802.3dj D1.3

Comment Resolution

Electrical Track

Figure 120G-6—Example host output test configuration

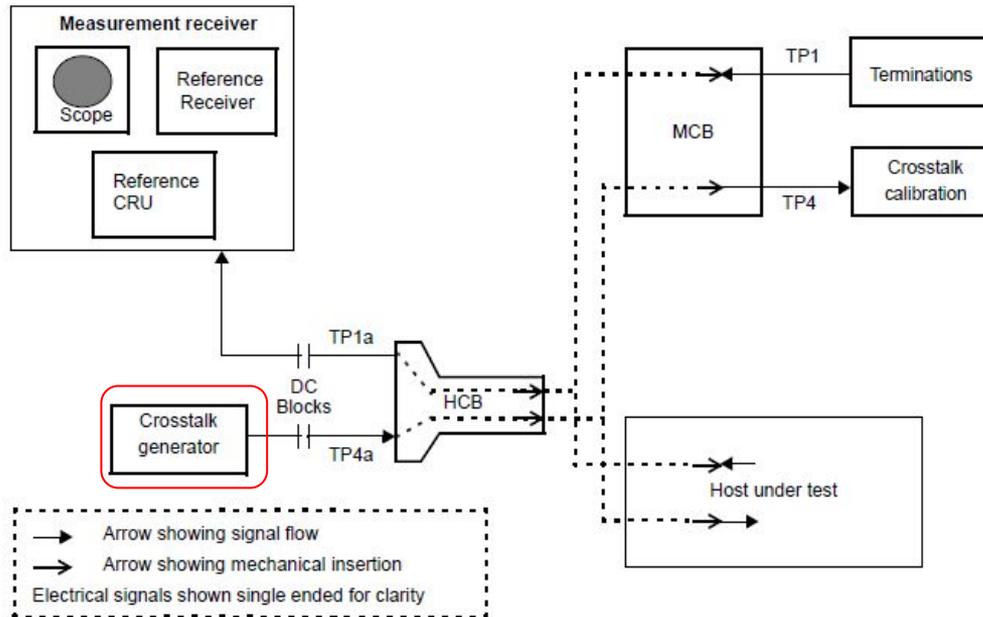
Previous generations of C2M specs had a “Crosstalk generator” fed into the input as part of the host/module output tests (which resulted in EH and VEC).

The crosstalk generator output is specified to be an asynchronous pattern with maximum differential peak-to-peak and minimum transition time at TP4. Equalization is not specified.

However, 1000 mV peak to peak at TP4a would likely violate the vf specification, and the initial setting of the module may be different. Also, rise time is currently unspecified.

The editor's proposal is to add a similar requirement with slightly different wording, as shown below, and include a NOTE informing the reader of the importance of the input signals.

NOTE—The input signals are included to excite the NEXT that will be present when a module is plugged into the host under test.

OUT_OF_SYNC state in Figure 178B-10

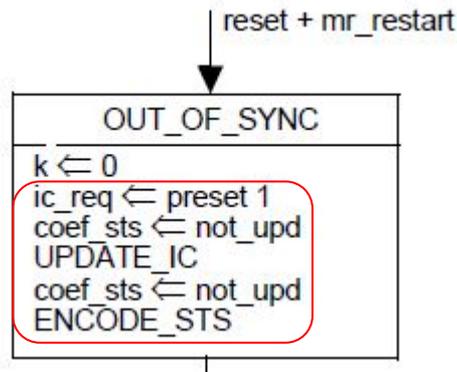
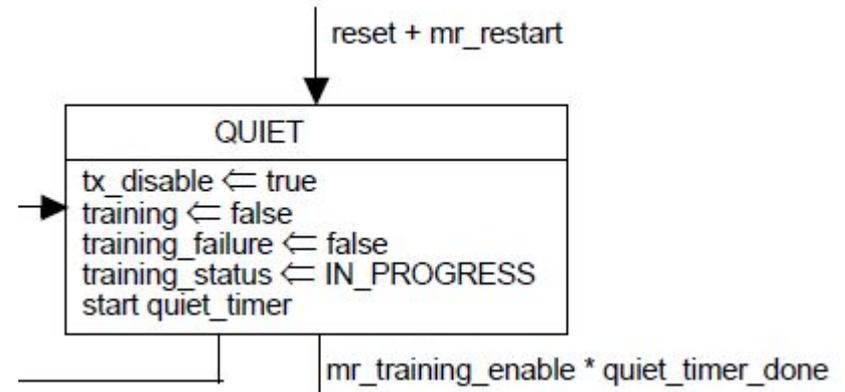
The marked part should be modified to enable a separate initial setting.

Note that **both diagrams enter these states in response to the same conditions, reset + mr_restart** (QUIET is also entered from SEND_LOCAL, but only when training is disabled. In that case there is no change of coefficients). Therefore, **there is no need to set the equalization state explicitly to "preset 1" in the QUIET state** (as in the current text of 178B.11.2). Also, UPDATE_IC includes setting coef_sts to not_upd, so its assignment in OUT_OF_SYNC (twice) is redundant.

Proposed actions in OUT_OF_SYNC state

OUT_OF_SYNC
$k \leq 0$ ic_req <= initialize UPDATE_IC ENCODE_STS

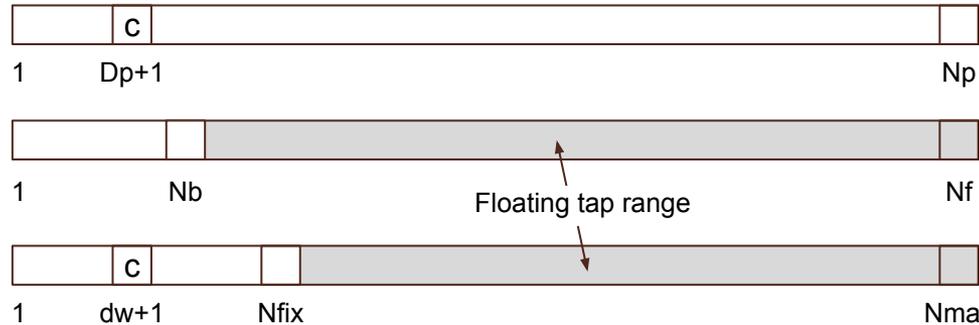
Comment points out that tap indexing conventions for the feed-forward filter are unclear. A summary of various tap indexing conventions is below.

However, it does not look like the N_{max} values in Clauses 178 and 179, and Annexes 176C and 176D, are consistent with this convention. E.g., for a floating tap range of 80, N_{max} should have been set to $dw+1+80$.

Add the following text to 178A.1.8.1 to explicitly state the tap indexing convention for the feed-forward filter:

“By convention, feed-forward filter tap index 1 corresponds to the earliest pre-cursor tap, tap index N_{fix} corresponds to the latest fixed-position post cursor tap, and N_{max} corresponds to the highest index that can be chosen for a floating tap. This means that the feed-forward filter includes $N_{fix}-dw-1$ fixed-position post-cursor taps and a floating tap range of $N_{max}-dw-1$ taps.”

So, in addition, change N_{max} in Clauses 178 and 179 to $6+1+80 = 87$ and in Annexes 176C and 176D to $5+1+50 = 56$.

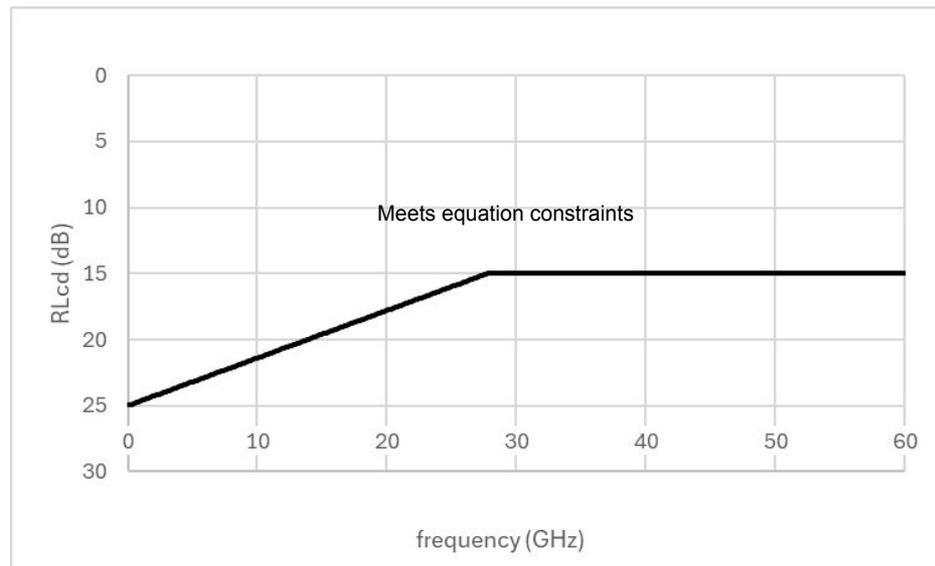
The differential-mode to common-mode return loss is TBD. It is an important parameter for system performance, but proceeding to working group ballot will be delayed if values are not available. Without further evidence that it could be relaxed it should be scaled from 100G.

Use $25-0.36f$ from 0.05 to 27.8GHz and 15 from 27.8GHz to 60GHz. Modify the editor's note on page 707 line 26 to still encourage further work.

PROPOSED ACCEPT IN PRINCIPLE.
Implement the suggested response with editorial license.

The comment proposes an equation for (176C-1) and figure 176C-5 to replace TBDs.

Figure 178-2—200GBASE-KR1, 400GBASE-KR2, 800GBASE-KR4, or 1.6TBASE-KR8 link

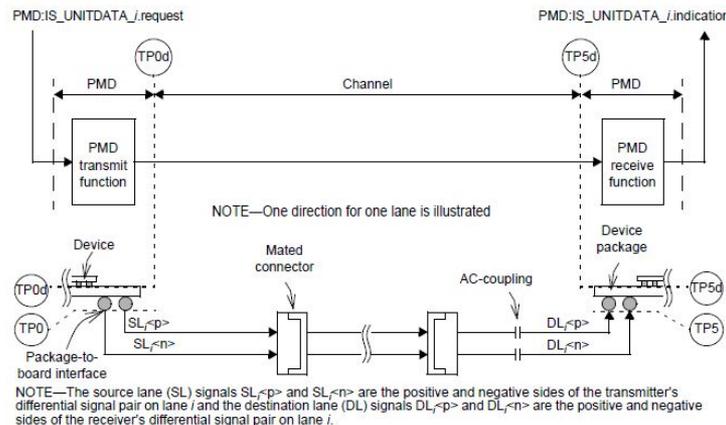
CI 178 SC 178.8.1 P339 L39 # 256
Ghiasi, Ali Ghiasi Qunatum/Marvell
Comment Type TR Comment Status D AC Coupling
Location of AC coupling may also be on chip and stating TP0 to TP5 would not allow that

SuggestedRemedy
Add note to the figure that AC coupling shown between TP3 and TP5 but actual implementation may be on chip.

Proposed Response Response Status W
PROPOSED REJECT.
The use of on-chip AC coupling is addressed in 178.10.6 and is considered to be an engineered link. There can be additional requirements from devices that are beyond the scope of the standard.
The proposed change would make operation without on-board AC coupling a requirement from all devices, which is a new idea that has not discussed.

The standard states that systems with no AC-coupling in the channel are considered engineered links and the system integrator has the responsibility to verify that Tx & Rx are compatible with the CM voltage differences that may exist.
